Application No.: 10/693,534  
Atty. Docket: GOJ03030 (GOJ.P96US)

**Amendment of the Drawings:**

UNIVERSAL ADAPTER CLIP  
By: Nick E. Ciavarella et al.  
Replacement Sheet 4 of 4 Shannon V. McCue, Reg. U.S. 42,859  
File No. GOJ.P96US (GOJ 03030)

FIG. 5

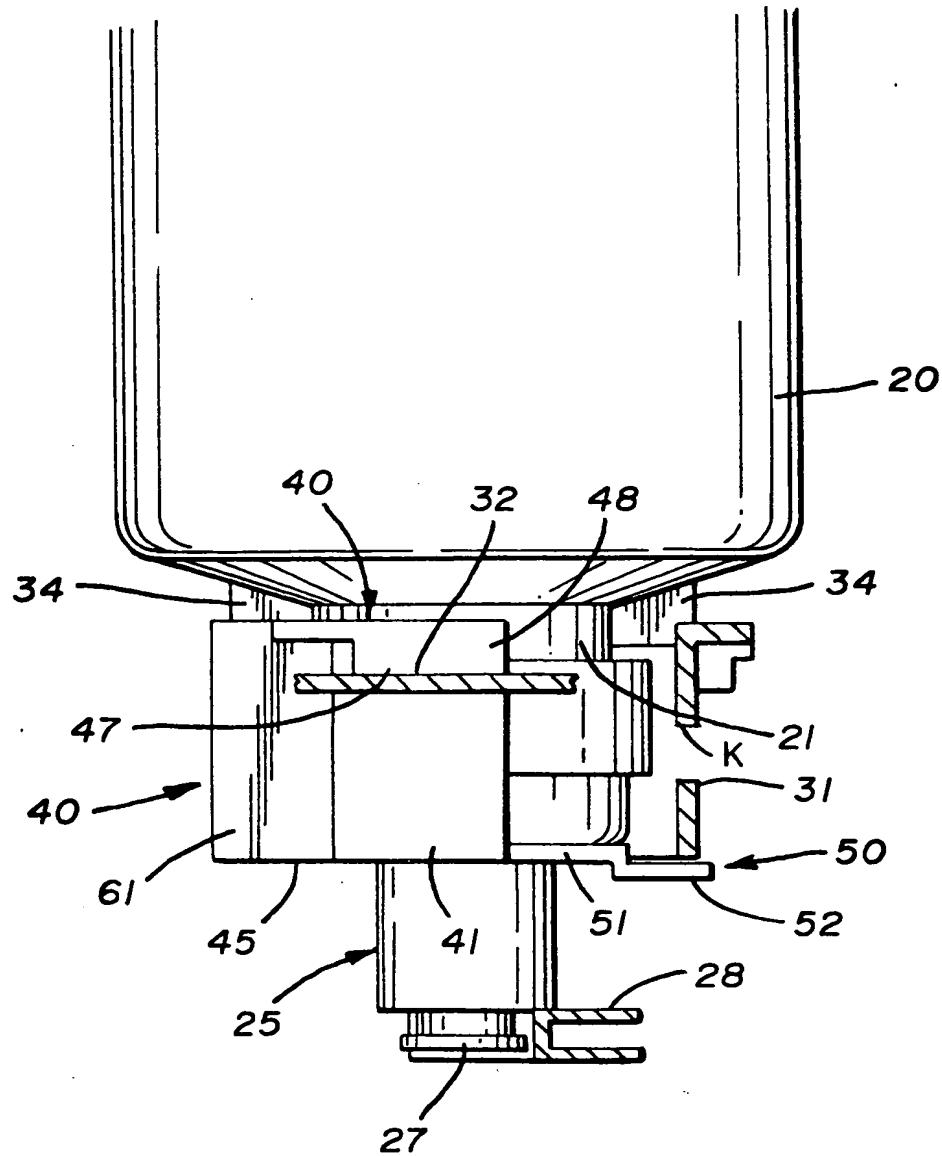
The Examiner objected to the drawings because they lacked reference signs 16, 17 and K. On page 4, line 29, the reference to a cover 16 appears to be a typographical error. This error has been corrected by changing the number 16 to 11b, which has been used to refer to the cover throughout the specification and in Fig. 1. On page 4, line 12, the reference to shoulder 17 has been removed. In making this correction, the Applicant noted that the word "pair" should appear before the word "shoulders" and the appropriate correction has been made in the specification.

With respect to the reference to a keyway K, the Applicant has provided a substitute drawing sheet 4 showing the keyway, as it is described in the specification as a vertical slot formed in the receiver plate 31 and indicated this keyway with the reference letter K. Consequently, the Application requests reconsideration of the drawing objections.

The attached sheet 4 of the drawings include(s) changes to Fig. 5. This sheet, which includes Fig. 5, replaces the original sheet 4 including Fig. 5. A marked-up copy highlighting the change to Fig. 5 on sheet 4 is attached for the Examiner's review.
